ADDENDUM #2

Reference: Parleys Maintenance Station #234 Improvements
Utah Department of Transportation - Utah
DFCM Project No. 08211900

ADDENDUM NO. 2 to the Contract Documents for the Construction of UDOT Maintenance Station #2434, Parleys Canyon, Utah.

C100

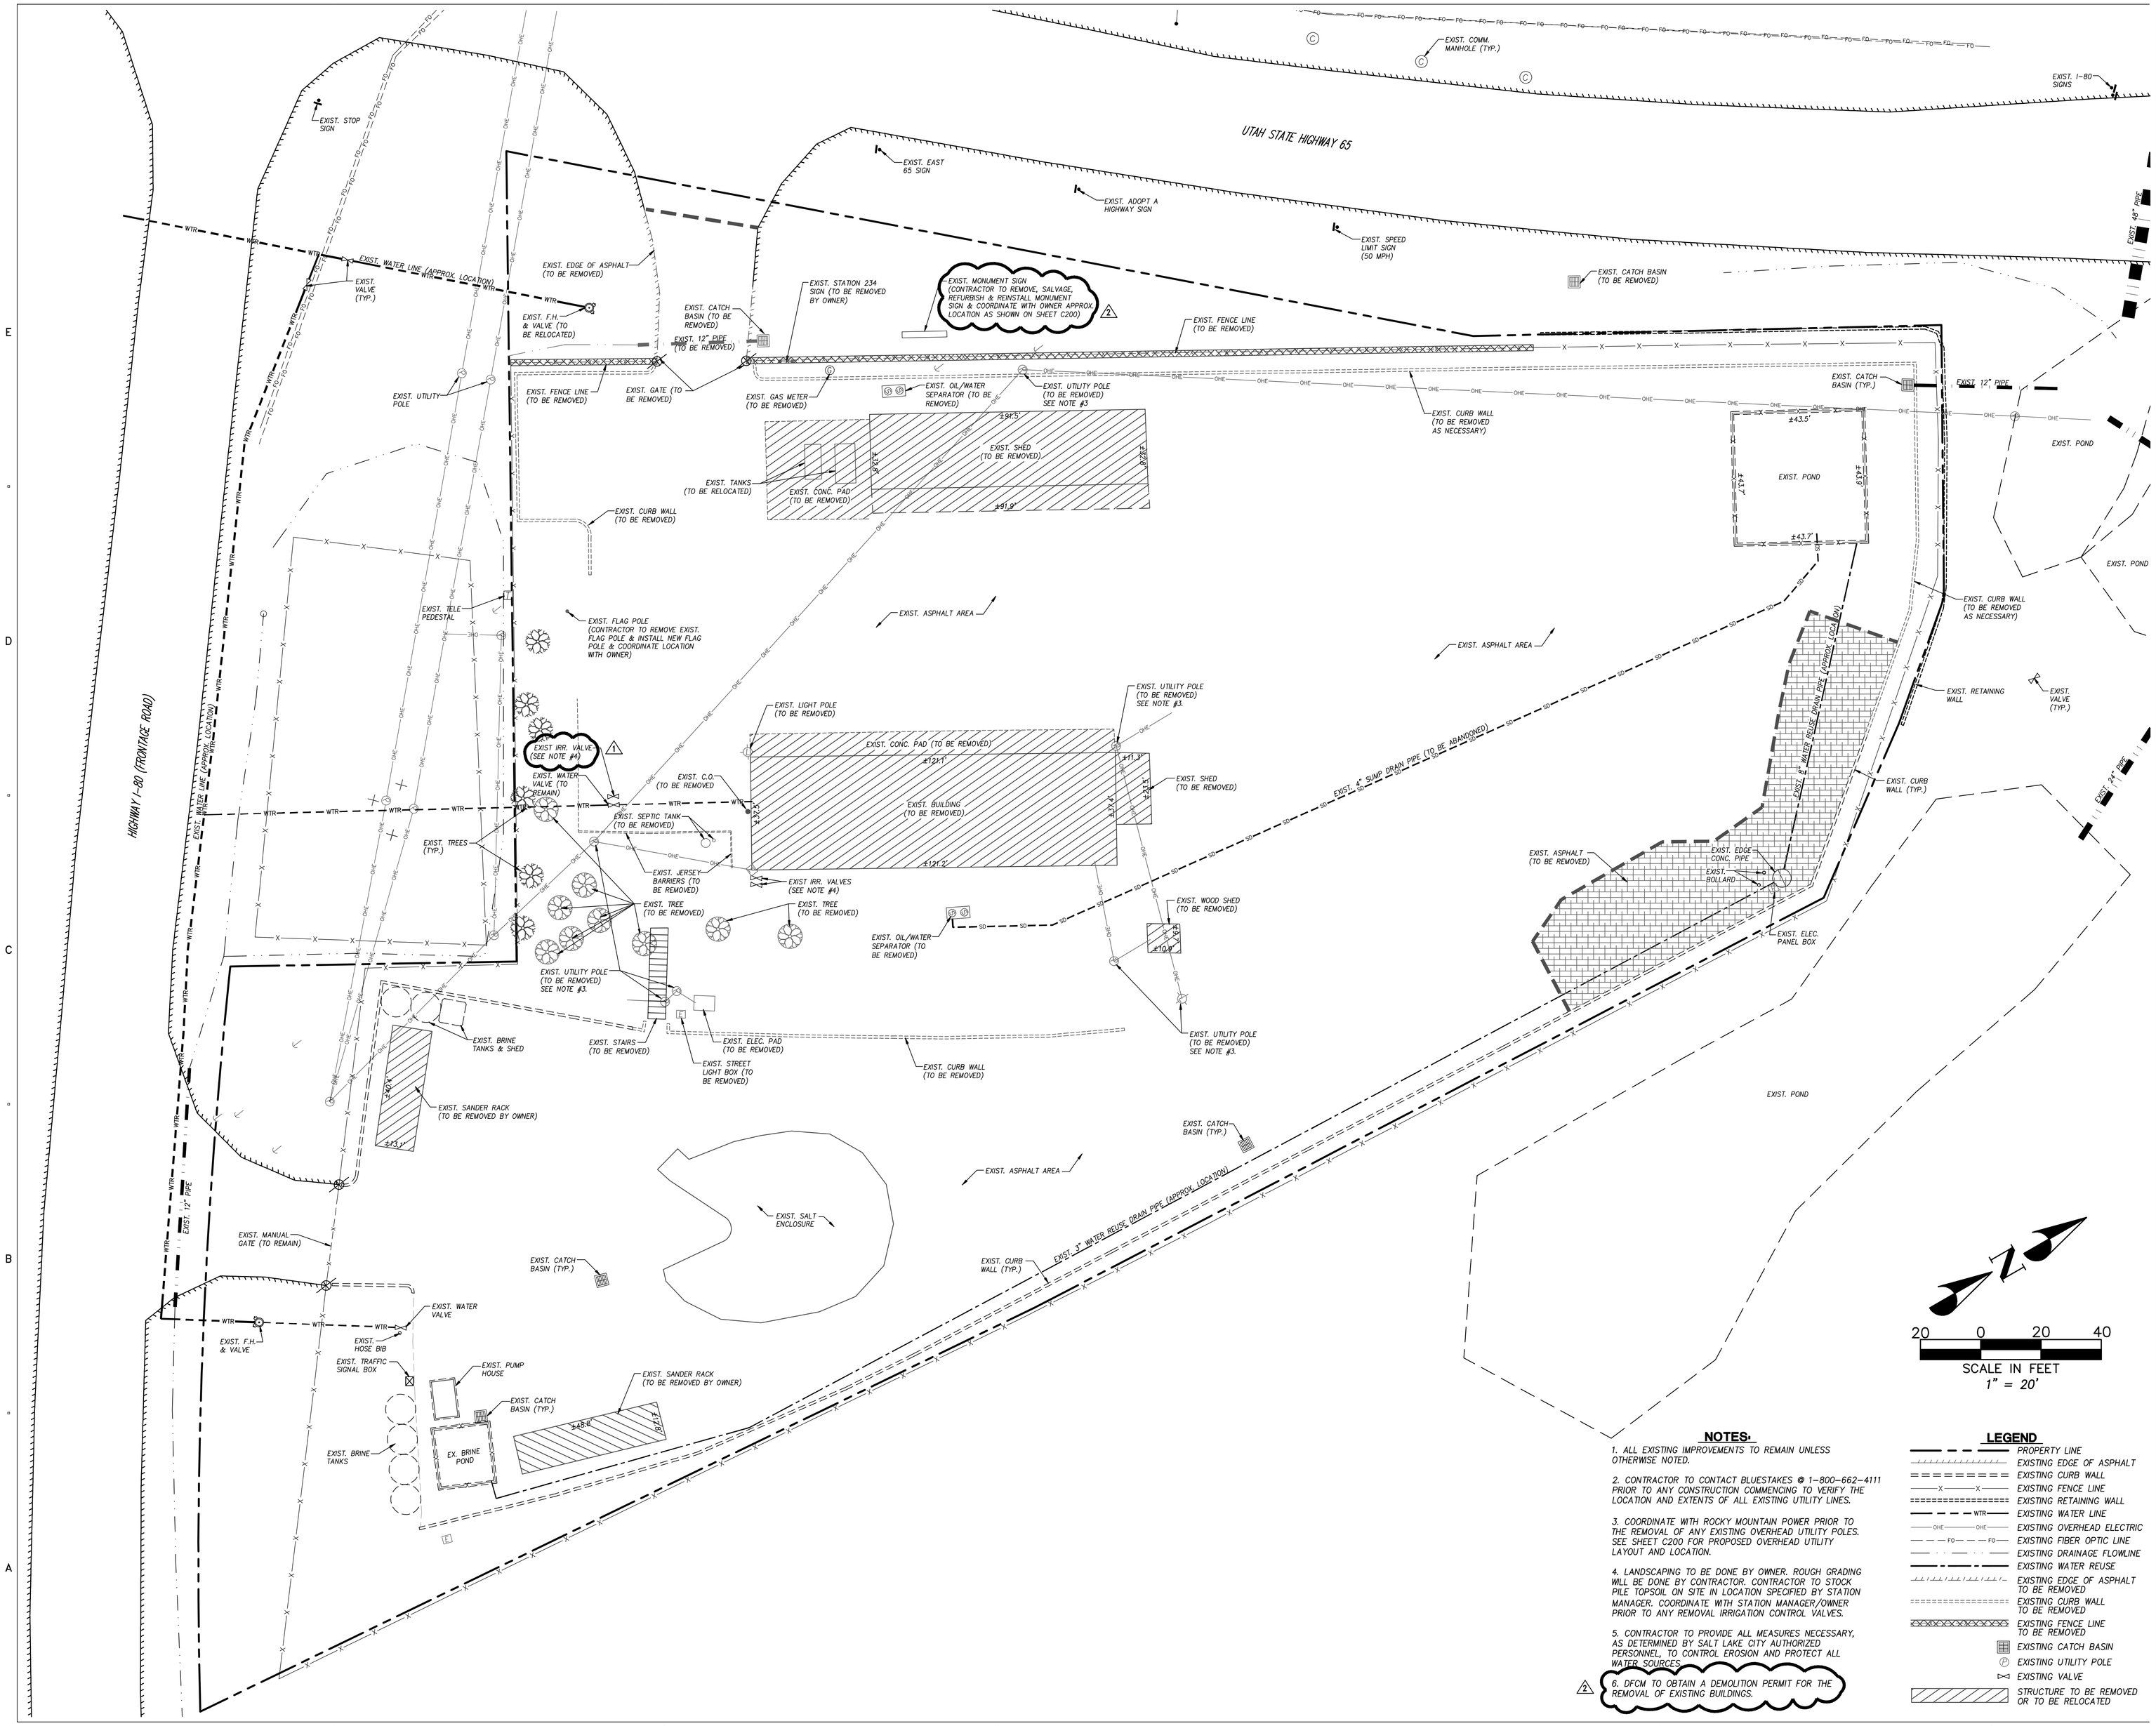
Sheet C100:

a. Modified Note #6.
b. Revised note concerning Existing Monument.

C301

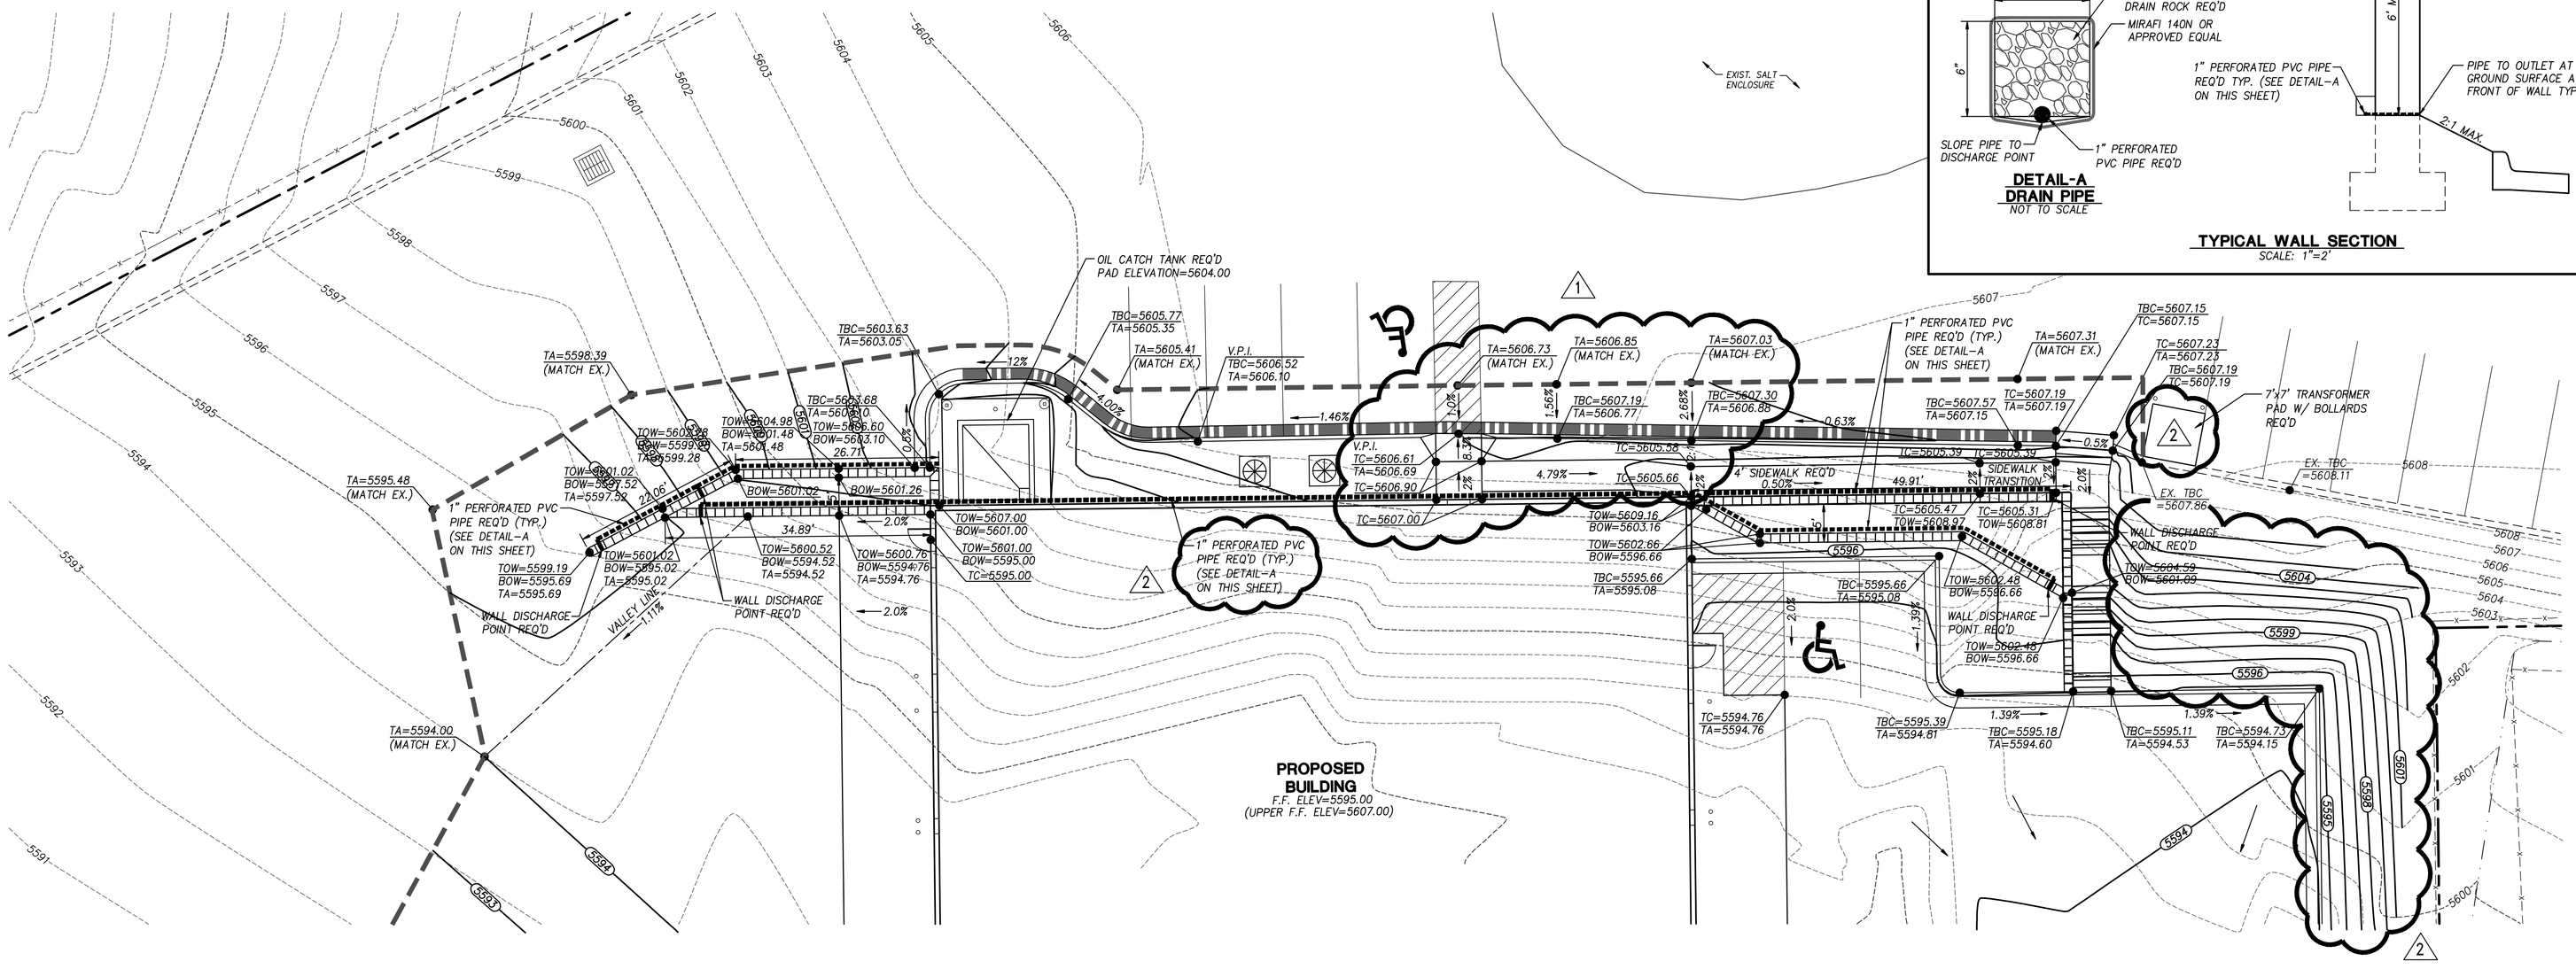
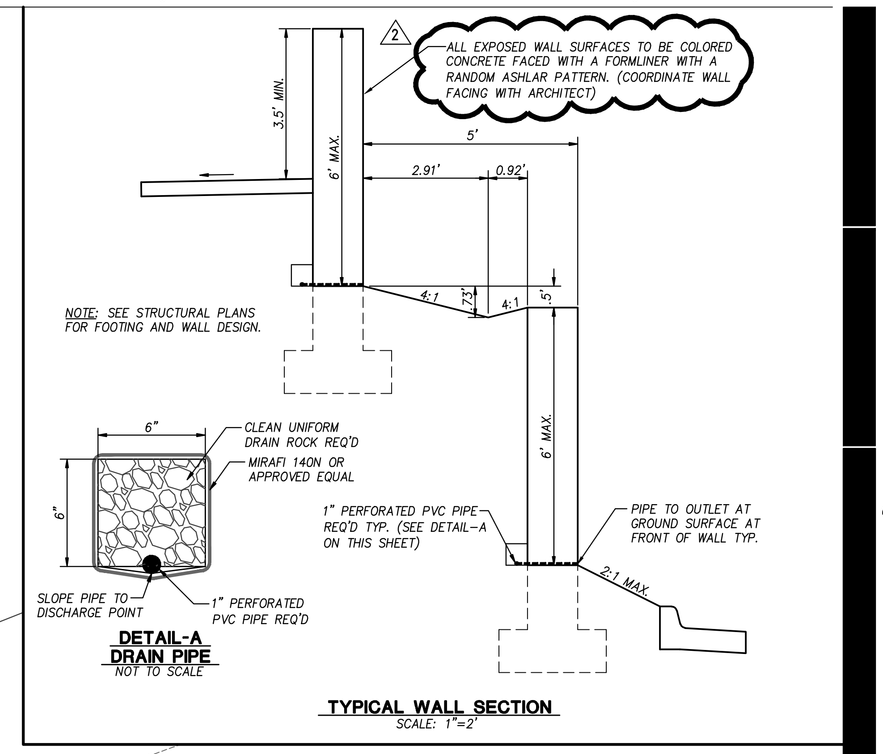
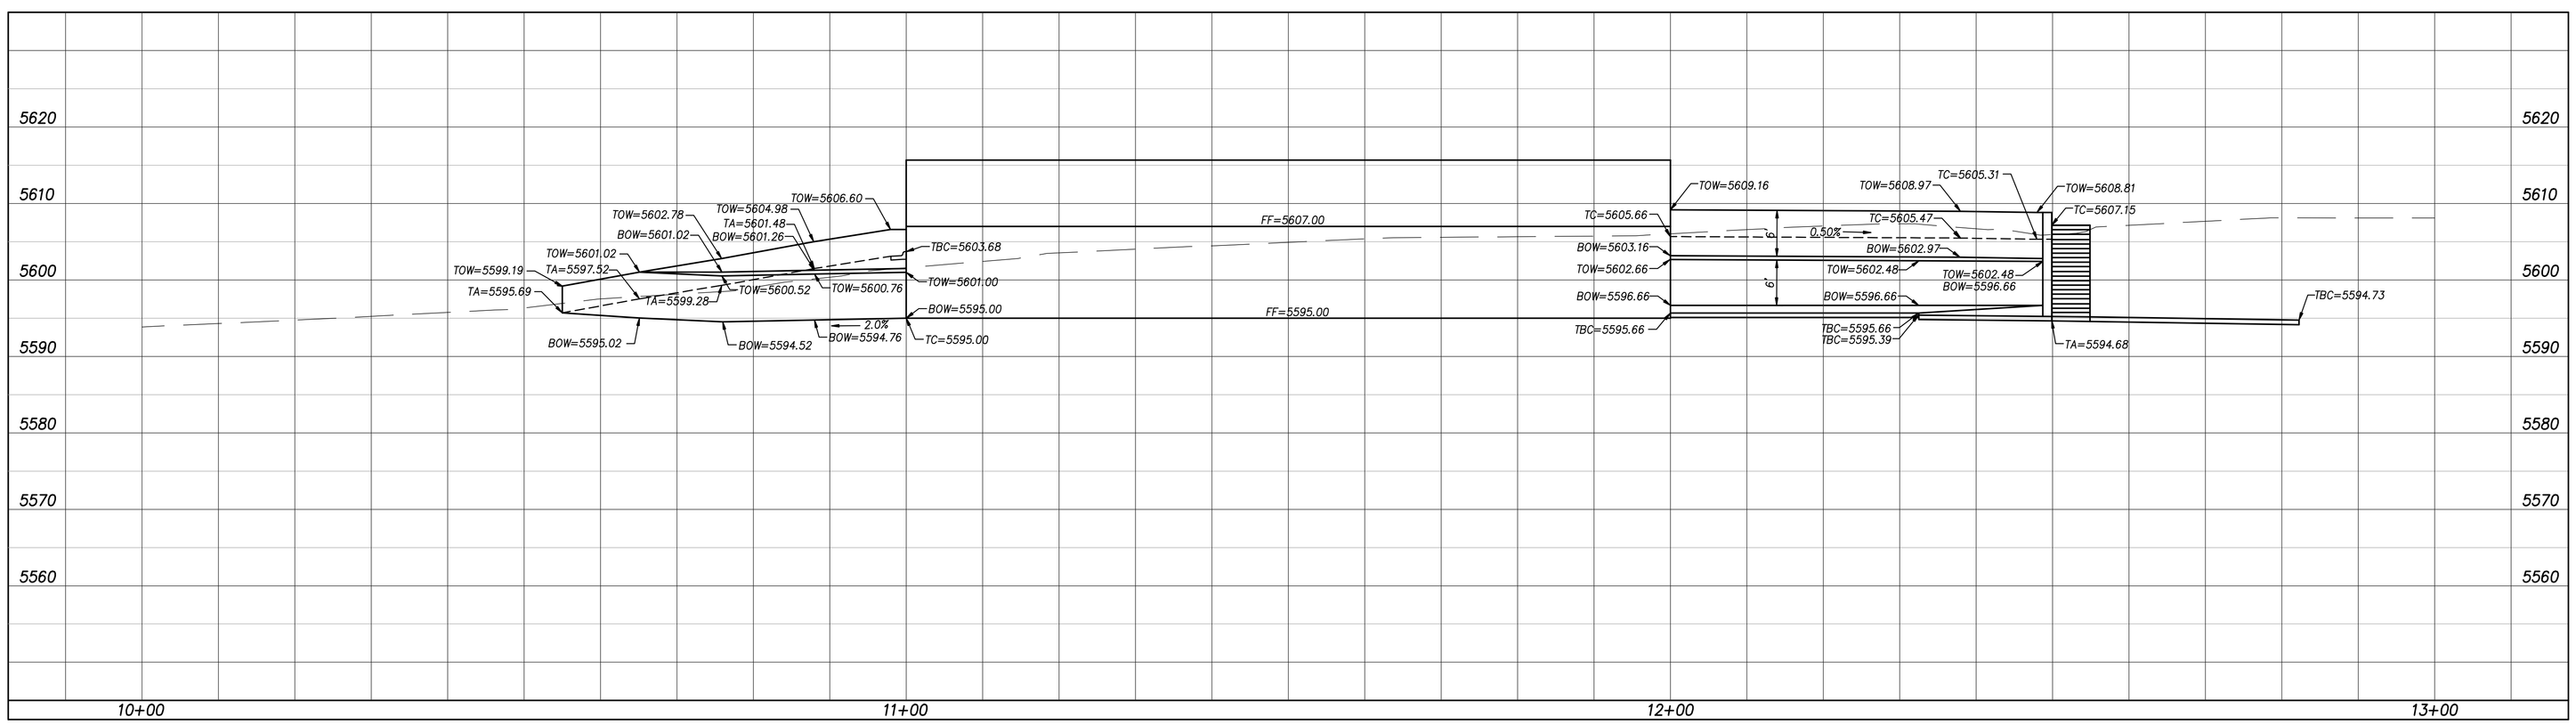
Sheet C301:

a. Modified typical wall section.
b. Add French Drain behind building foundation wall.
c. Relocated new Transformer Pad as shown.

d. Revised grading at hill to south of new concrete stairs as shown.
